RENESAS TECHNICAL UPDATE

Product Category	MPU/MCU		Document No.	TN-RX*-A202A/E	Rev.	1.00
Title	Errata to RX65N Group, RX651 Group User's Manual: Hardware		Information Category	Technical Notification		
Applicable Product	RX65N Group, RX651 Group	Lot No.	Reference Document	RX65N Group, RX651 Group User's Manual: Hardware Rev.2.10 (R01UH0590EJ0210)		
		All

This document describes corrections to the RX65N Group, RX651 Group User's Manual: Hardware, Rev.2.10.

Figure 60.54 RIIC Bus Interface Input/Output Timing and Simple IIC Bus Interface Input/Output Timing

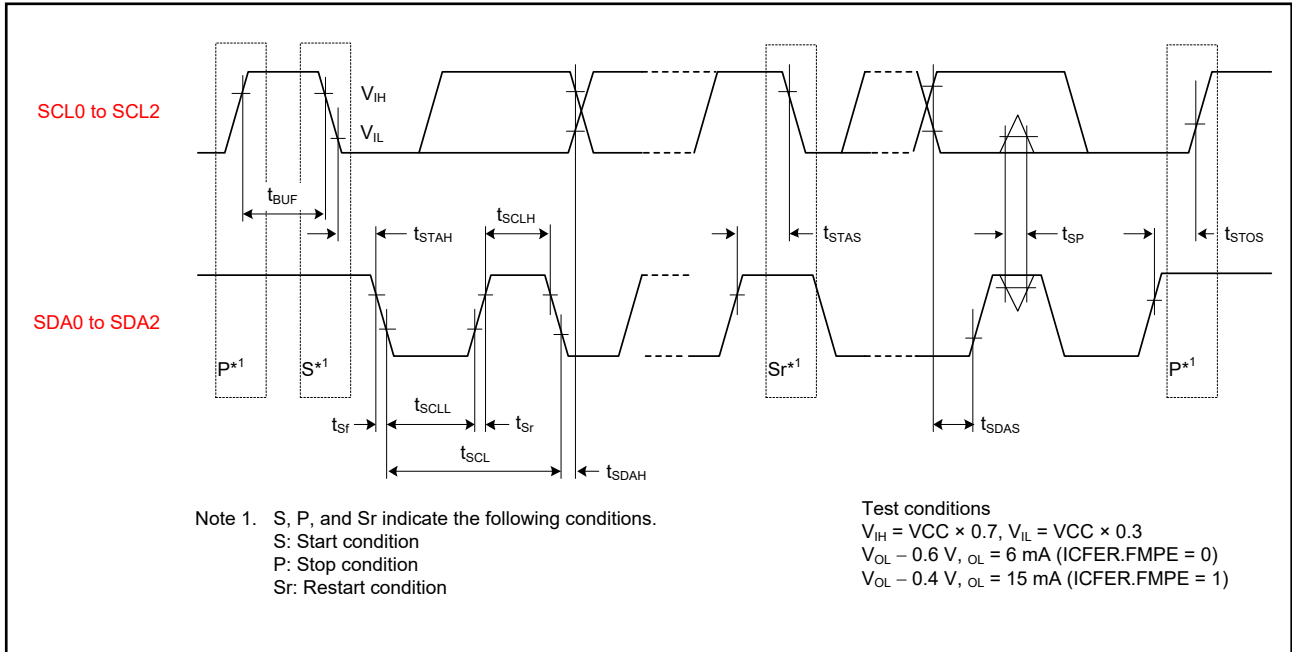
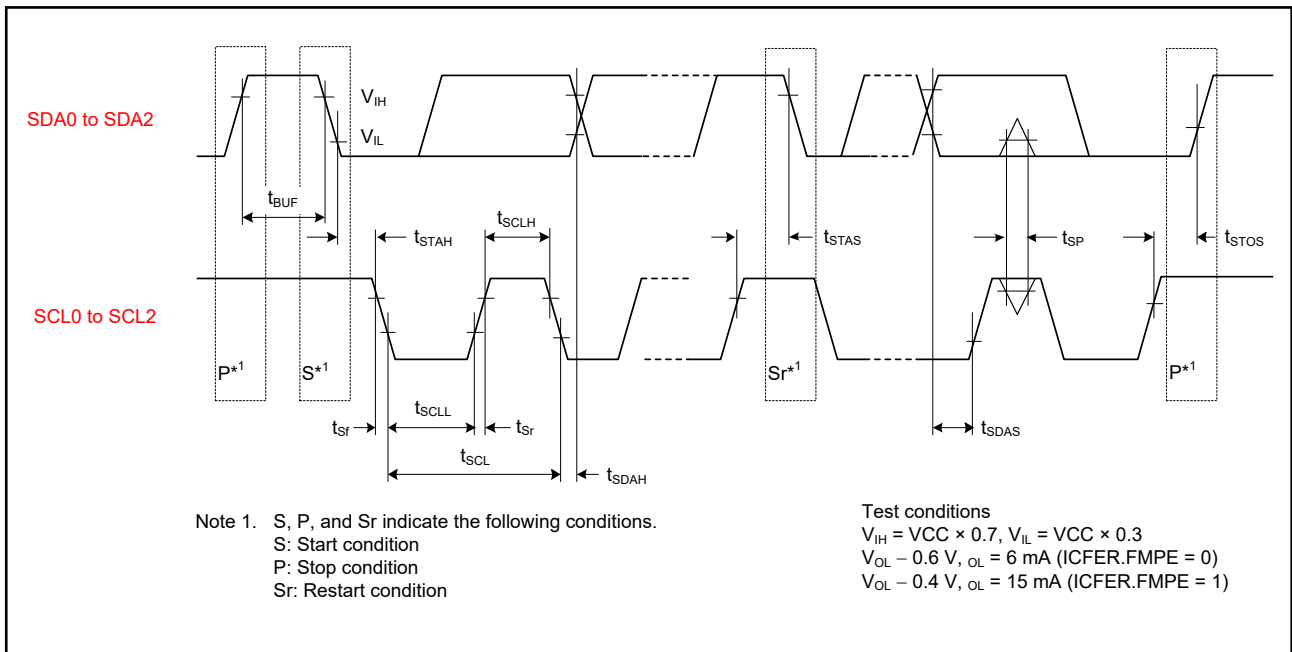
The signal names in Figure 60.54, RIIC Bus Interface Input/Output Timing and Simple IIC Bus Interface Input/Output Timing are corrected as follows:
